DOORS — MADE IN VENEER

Same design · Planted mouldings · Construction only

| REV<br>2 — the design unchanged; only the construction differs | DWG<br>AST-DR-015  |

PROJECT  
A Study in Teak — Doors — Made in Veneer

MAIN DOOR · 3 FT · AS AST-DR-001

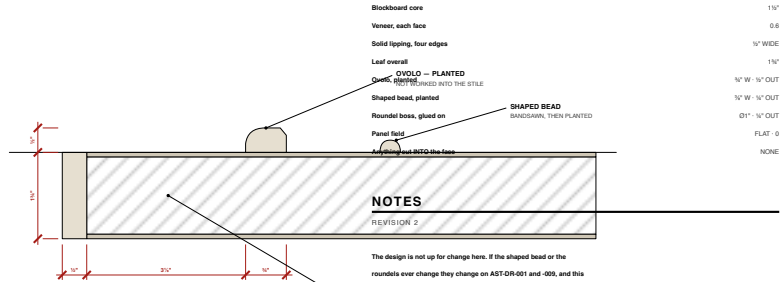
Both elevations are generated from the door sheets' own code, so the design cannot drift. Nothing on this sheet changes how the door LOCKS — only how it is made.

SCALE 1:2 (6" = 1'-0") @ A4 · SECTION ACROSS A PANEL · EVERY MEMBER PLANTED ON

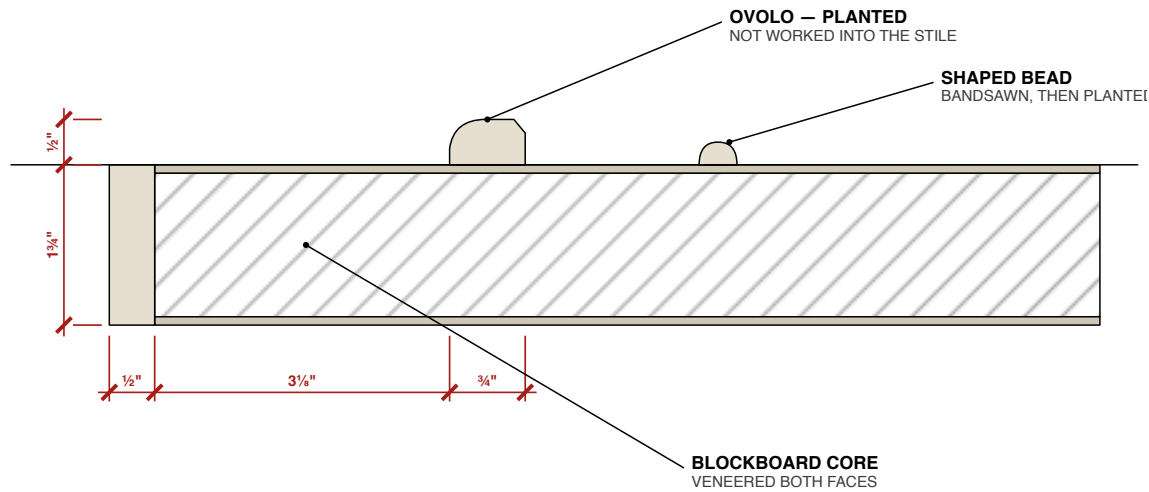
### Panel field

was: sunk ½" into the solid

now: stays FLAT — the ovolo round it does the work  
Ovolo sticking

was: worked on the stile edge

now: run as a separate ¾" x ½" moulding, mitred on  
Shaped bead

was: carved into the panel face

now: bandsawn to the curve in ⅜" x ¼", planted on  
Corner roundels

was: carved bosses

now: turned discs Ø1" x ¼", glued on  
The leaf

was: solid teak, 1¾"

now: 1½" blockboard, ½" lipping, veneer both sides

Lipping is solid teak on all four edges so the leaf can be trimmed

Veneer both faces of the core and balance it: same thickness back and front, or the leaf will bow.

Ovolo, bead and bosses in solid teak, polished to match. They are small enough to take solid without moving, and they give a crisper arris than a cut face would.

Set the bead out from the panel opening, not from the leaf edge, so the four roundels land exactly on the corners of the curve.

OPEN — glue and pin, or glue only? Pins need filling and the filler shows through polish. Glue and cramp if the shop can.
